VALUE ENGINEERING CHECK SHEET

VE 11-77

The contractor will reduce Class A quantities for a 825' fill section by using a 3:1 slope design instead of a 6:1 and adding a curb.

CROSS SECTIONS

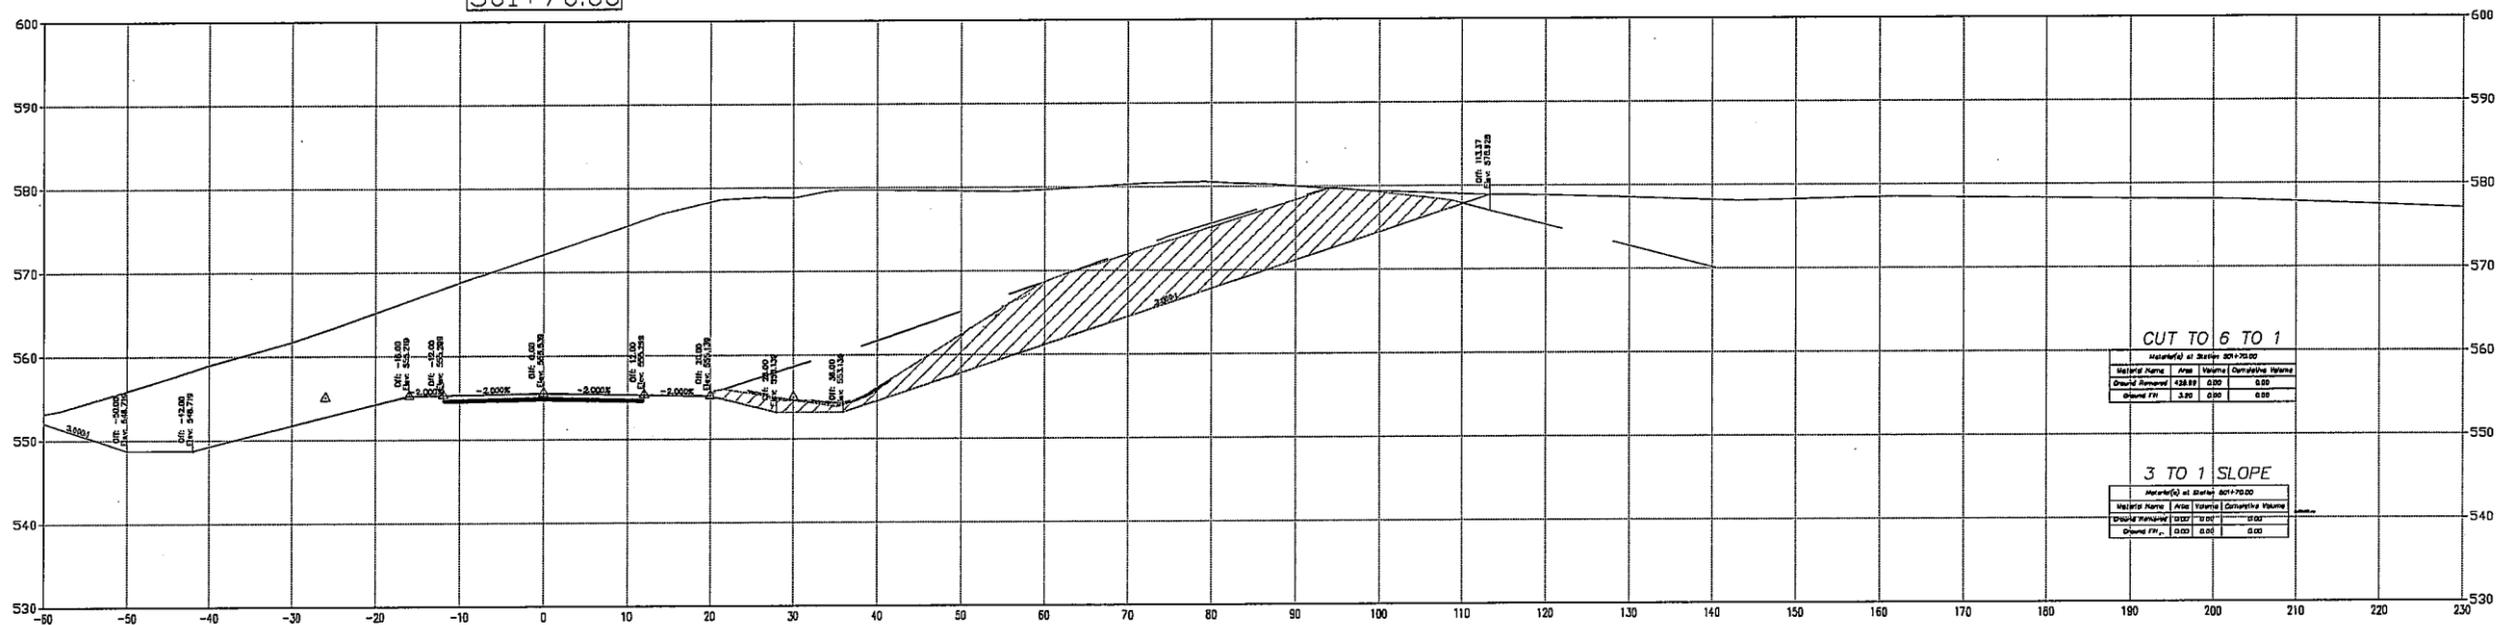
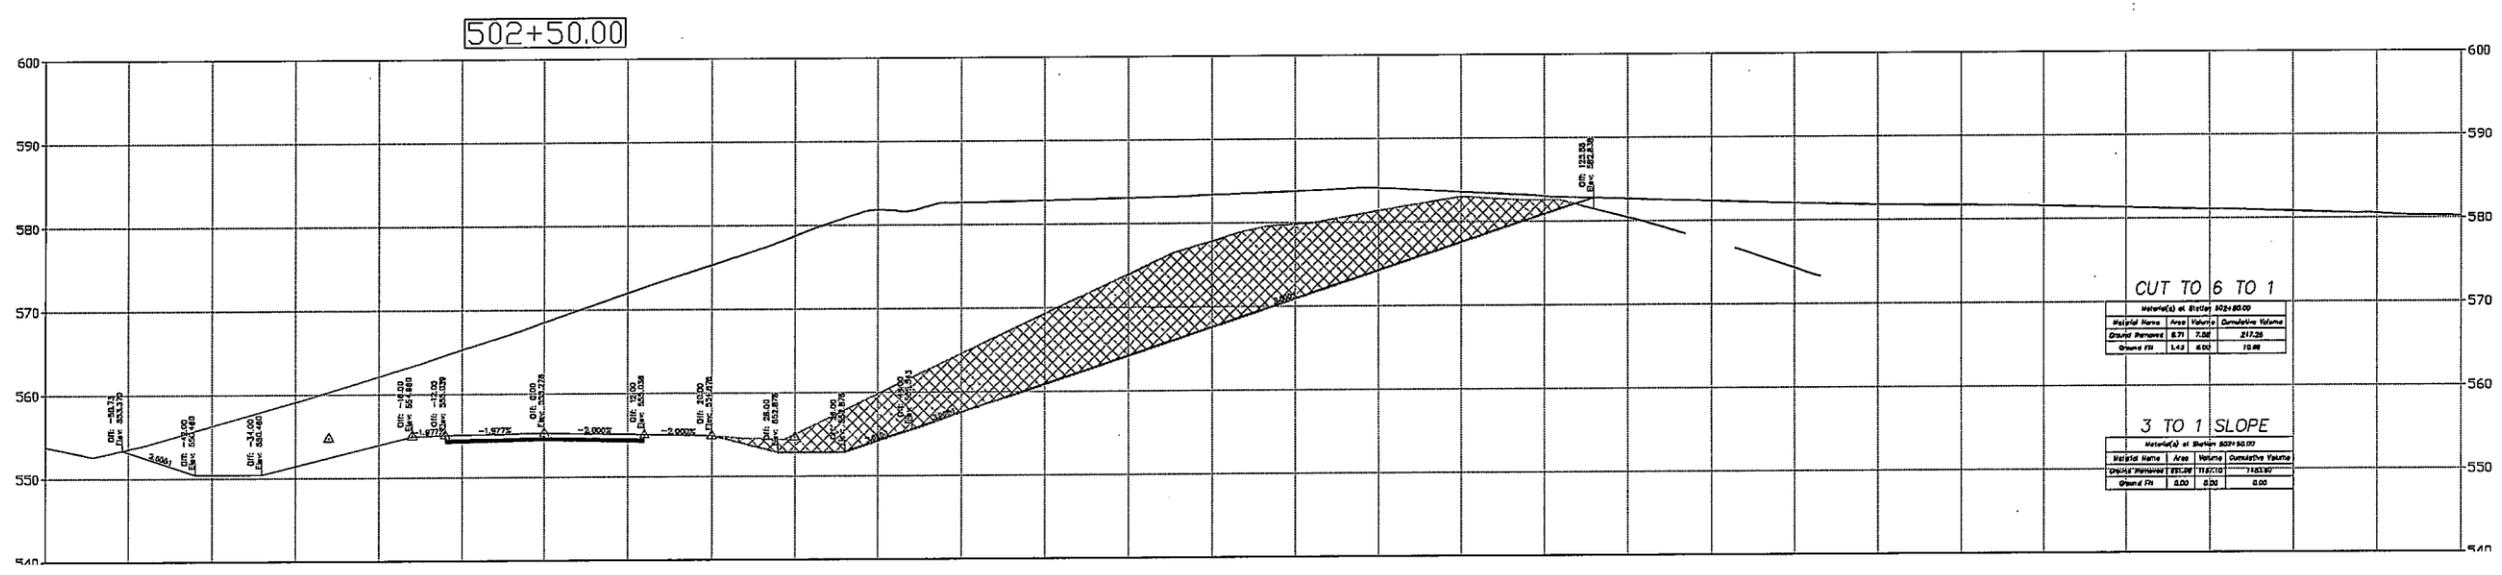
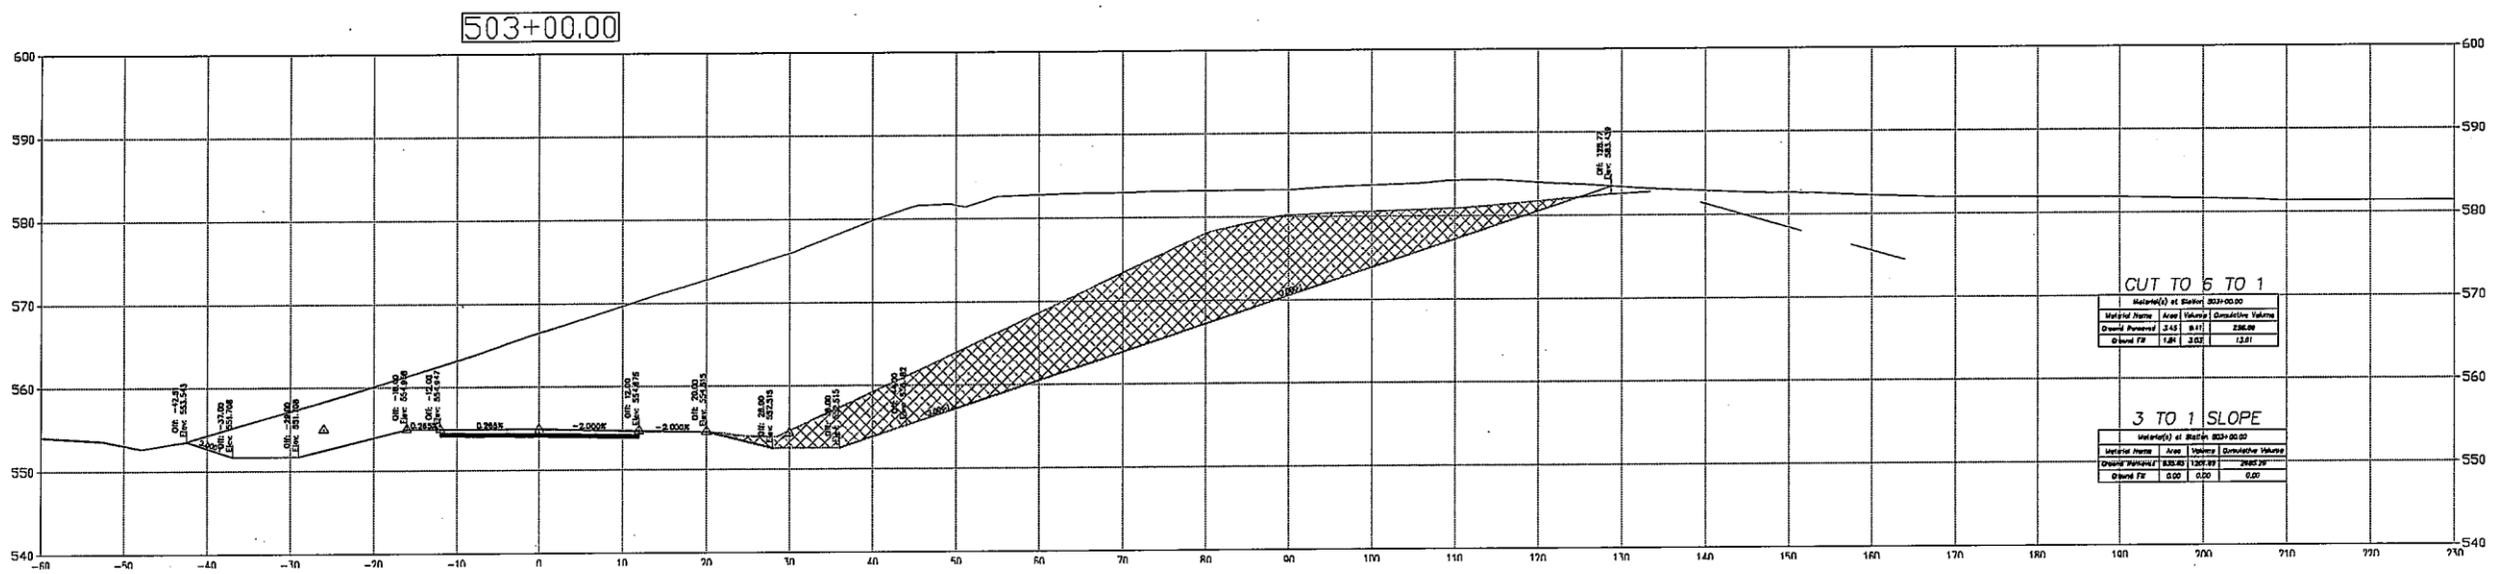
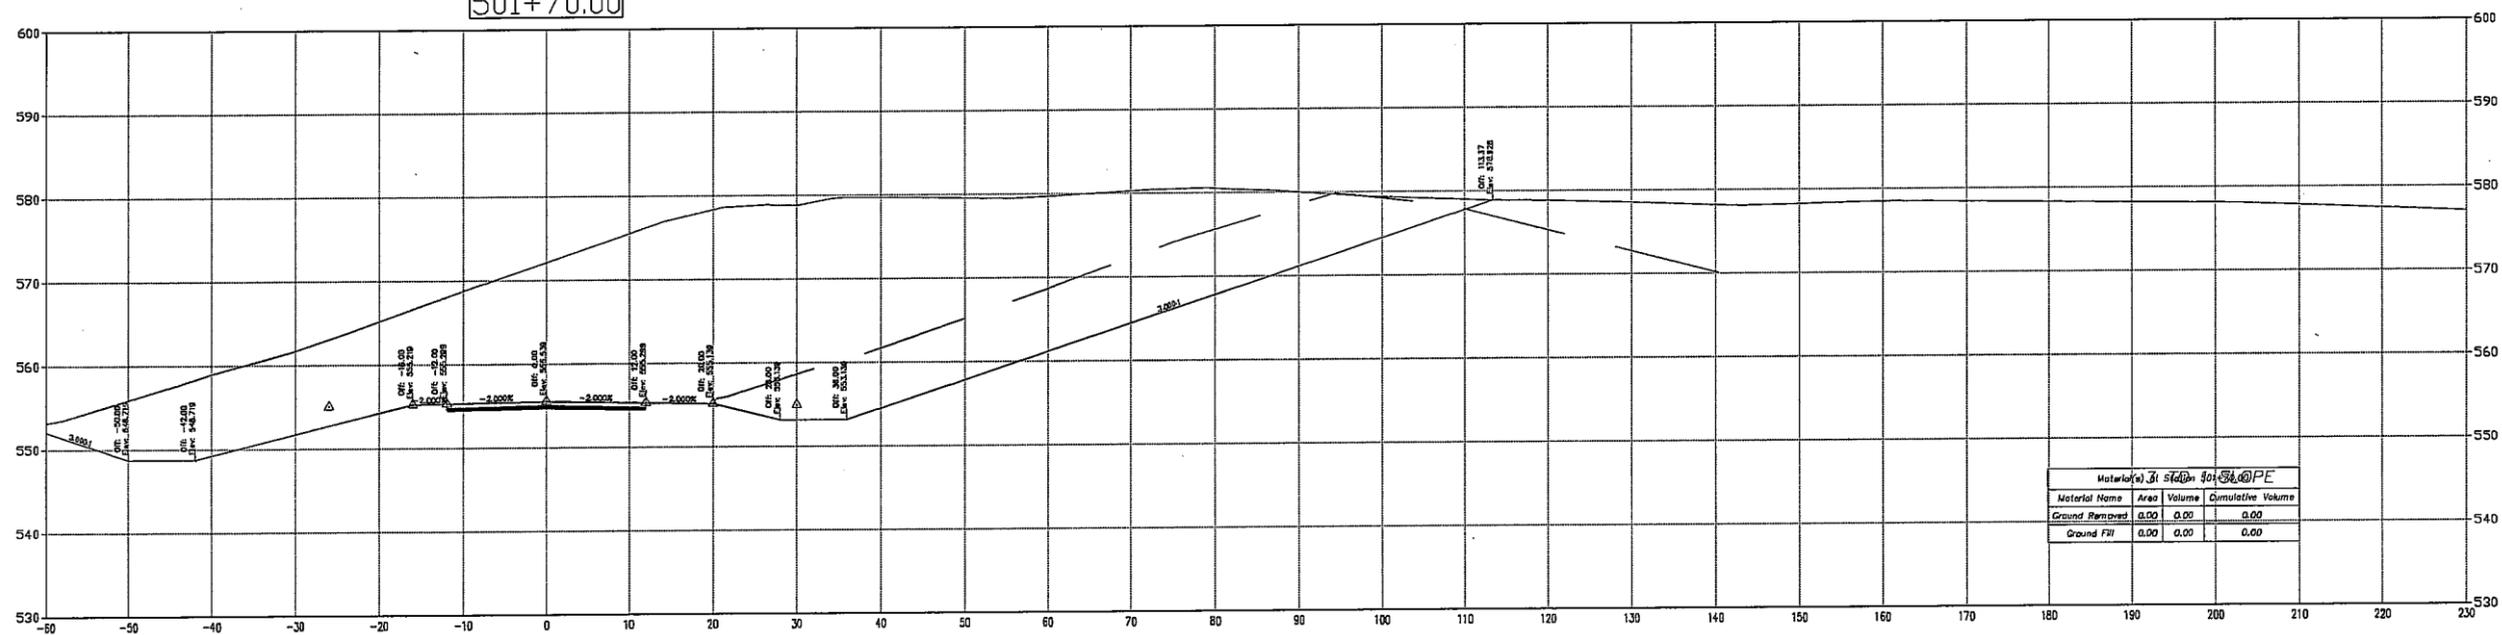
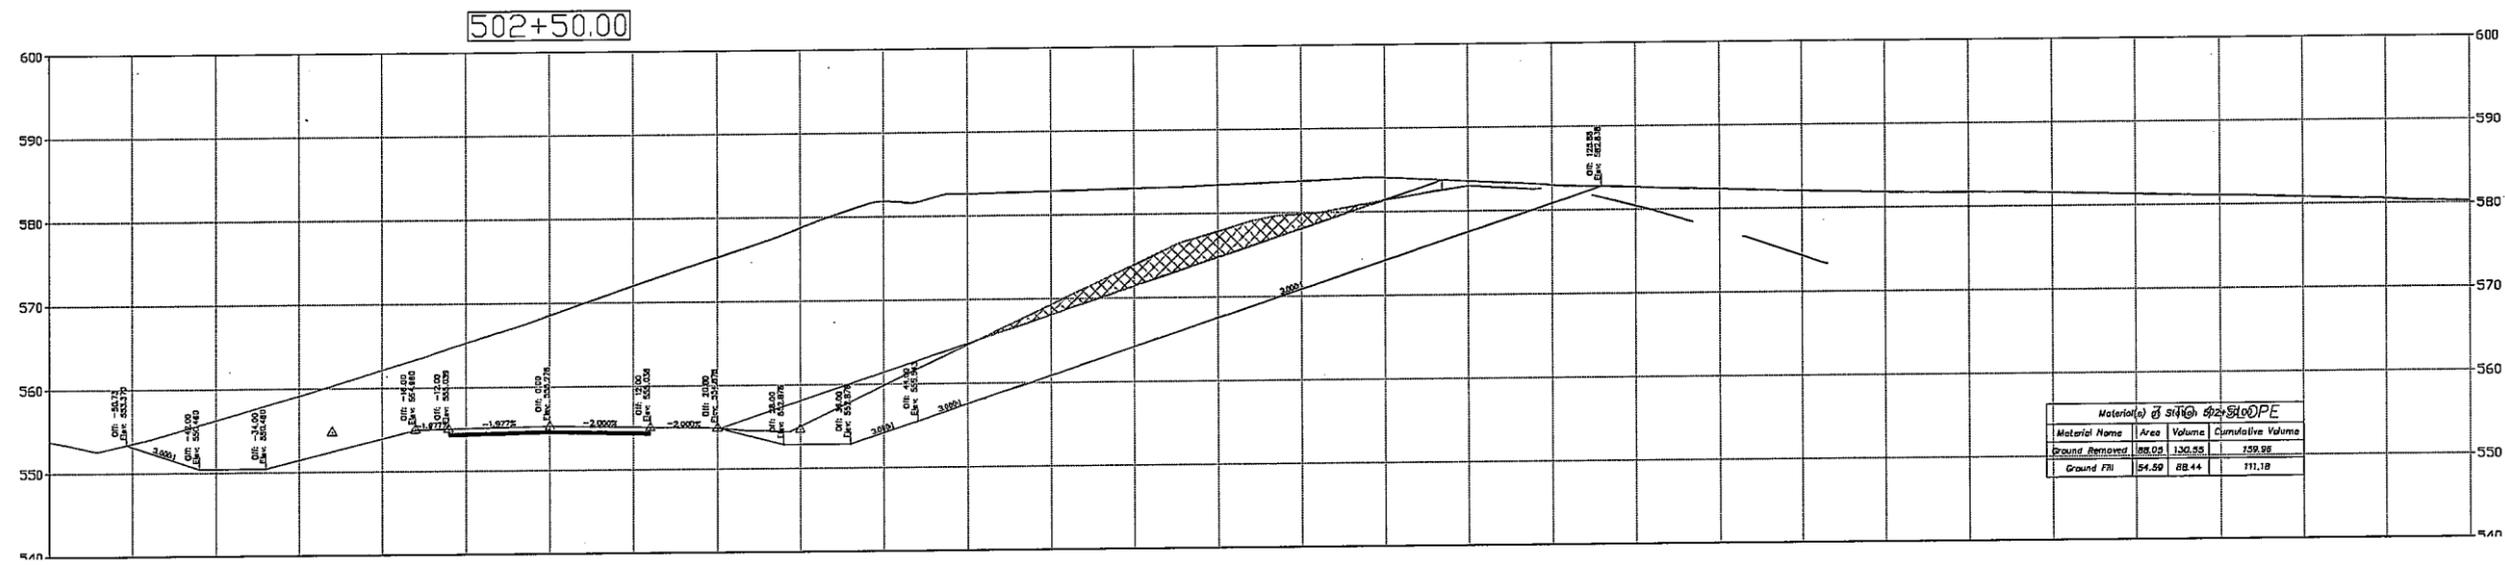
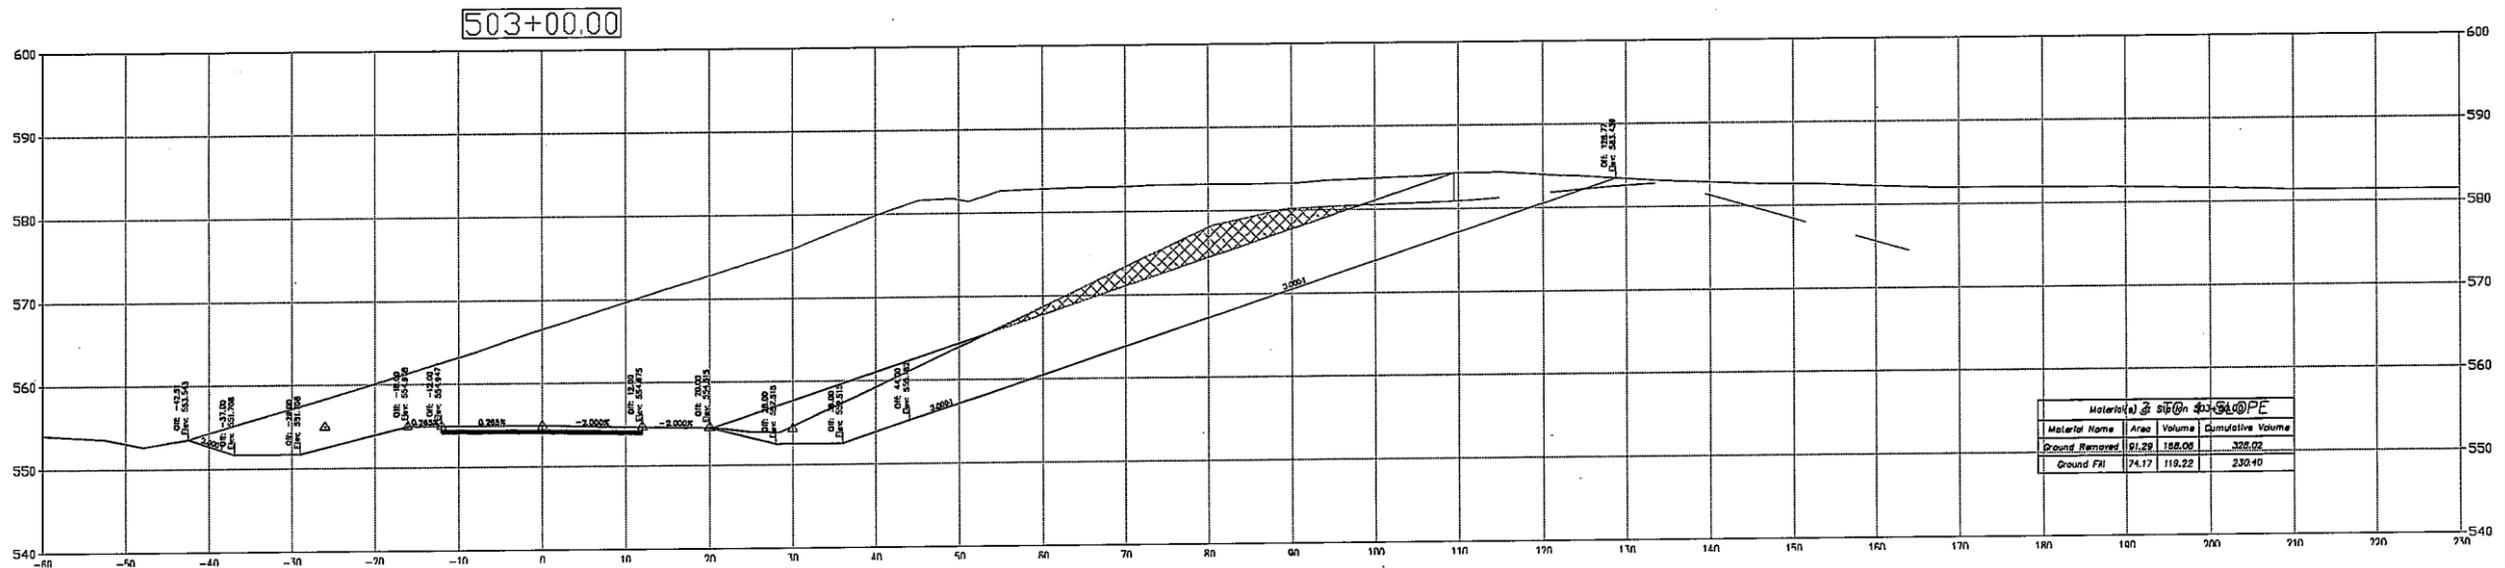
The 27,006 CY from above and proposed for elimination made up a substantial portion of the high production excavation on the job. Since this VECP changes production for the remaining qty, FWI proposes to completely under-run the current Class A item and add two new ones. One would be at a higher price (131,554 CY at \$7.23/CY) to offset the loss of high production excavation. The other item would cover the cost of establishing the new SOR grades (2,741 CY at \$3.50/CY). A breakdown of the savings is attached.

The proposed PDVECP will provide an acceptable product by changing slopes from 6:1 to 3:1. Approve of changing unit price of Class A because production rates of Class A will change

This PDVECP concept is approved. The change order will need additional information and justification regarding the revised unit prices for the Class A material. We will also need verification from the designer that the drainage changes are acceptable.
